March 20, 1997

Radioactive Materials Program
Attn: Eric T. Jameson
4244 International Parkway Suite 114
Atlanta, GA 30354

Thank you for the letter of March 11, 1997 requesting more information on the SS&D evaluation submitted for the Coalscan 2600. I will answer your questions in the order you asked.

Figure 1. Close-up of shutter lever and indicator

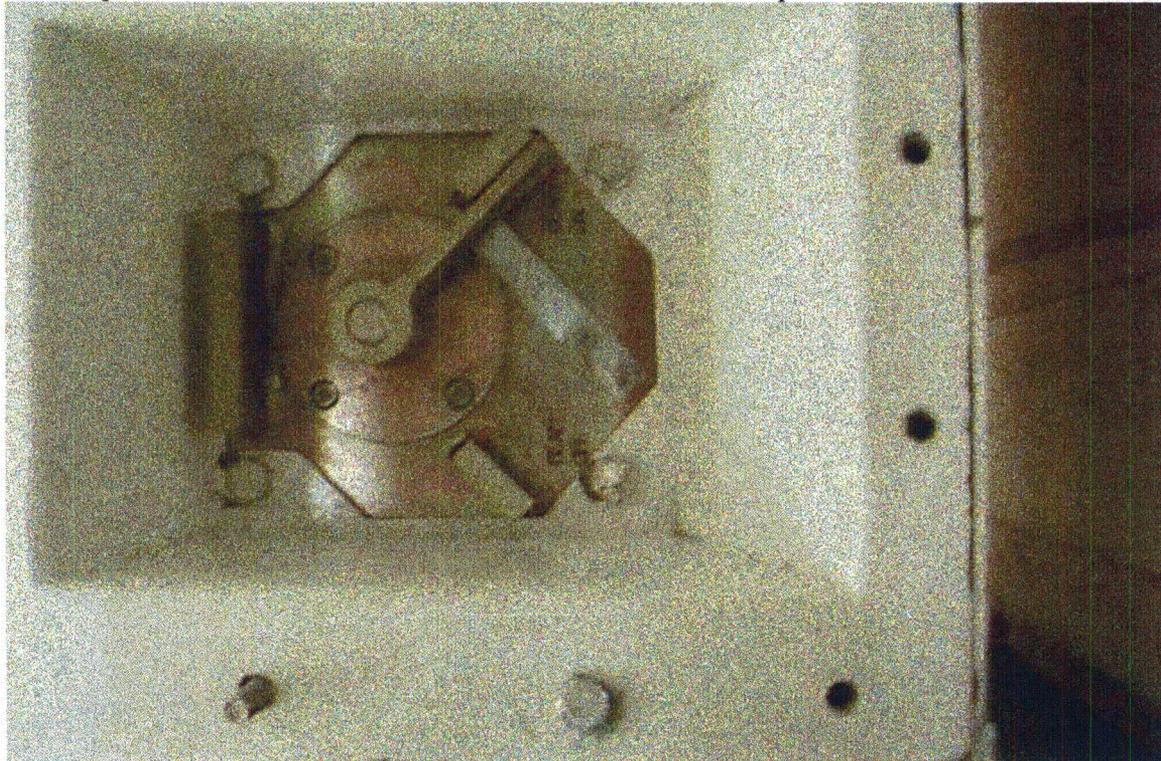
4. The shutter mechanism is entirely manual, with no electrical or mechanical connections or indications located remotely, including the remote operators console. The shutter status will be known at the remote operator station due to failure of the measurement when the shutter is closed. However, this should be considered "useful information" and should not constitute an official indication of shutter position. The only accurate determination is by the mechanical handle/indicator on the device itself. A close-up photo of this handle/indicator is shown in Figure 1 below. This photo shows the handle that opens and closes the shutter and also serves as the shutter status indicator. When in the off position, a padlock can be inserted to lock the shutter in the off position.
